Intel® 82571EB/82572EI Ethernet Controller

Specification Update

January 2012
Revision 6.5

26. Firmware Reset Occurs when Performing Transactions with a Low Interpacket Gap (IPG) Using Fast Management Link (FML) at 8MHz.

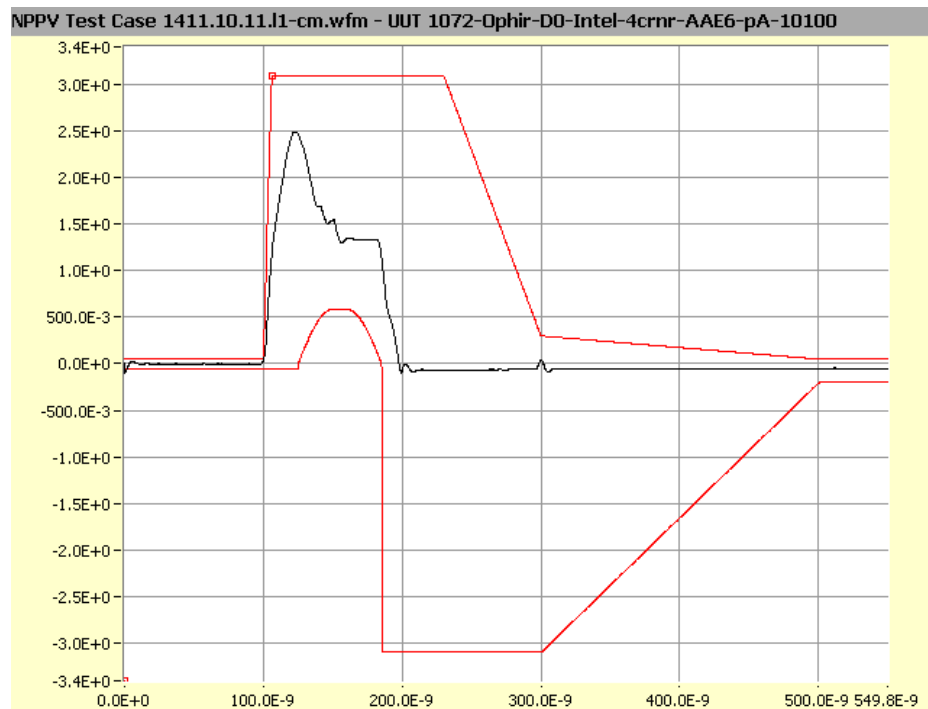
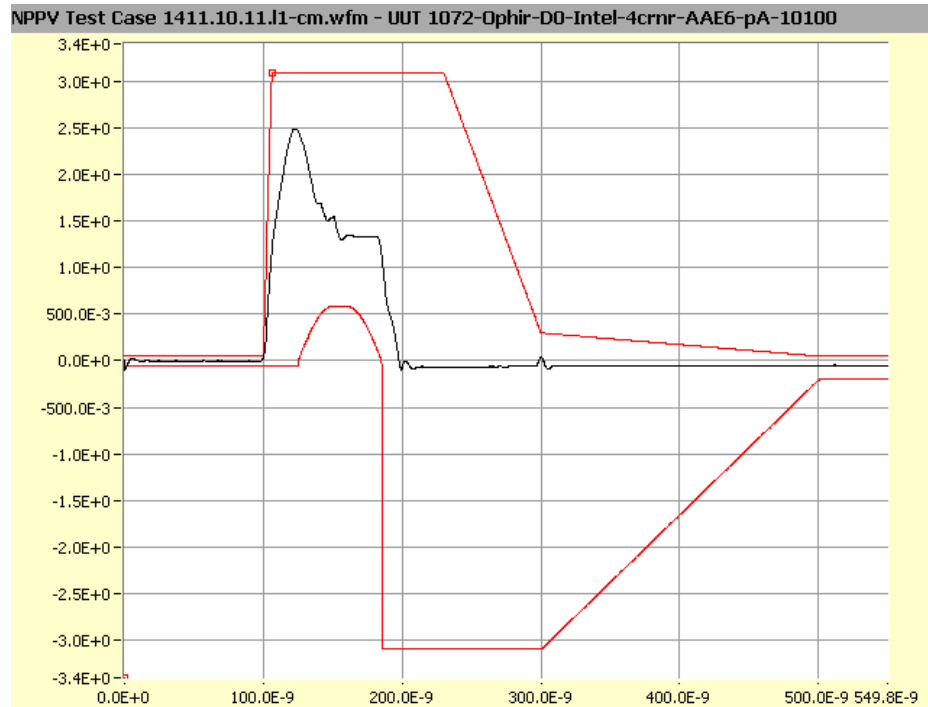
Problem: A single firmware reset occurs when FML 8MHz transactions are delivered with an Inter-Packet-Gap (IPG) smaller than 20uSec. Due to speed and memory limitations, buffers of BMC frames being arranged into Ethernet packets are incorrectly released. As a result, a memory error (Null pointer exception) occurs.

Implication: Performance impact. The BMC must retry the corrupted transaction.

3. System-Level EMI Test Can Be Affected by 490MHz Harmonic Seen In 10Base-T Waveform Spectrum.

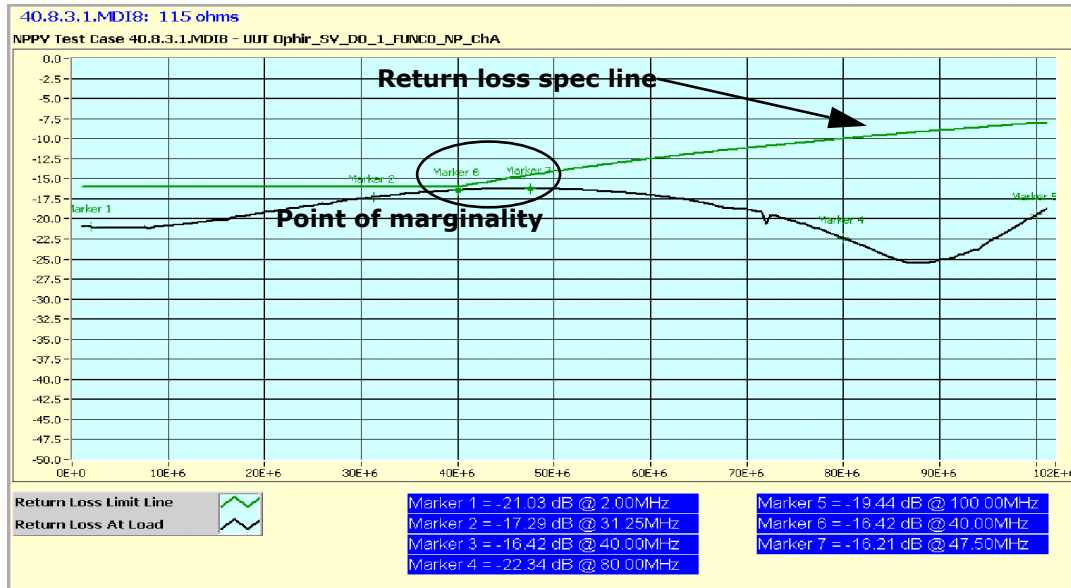
Clarification: This is not a violation of any IEEE specification. This harmonic may, however, contribute to EMI (electro-magnetic interference) in a system-level check at this frequency.

There is no impact on system-level performance.
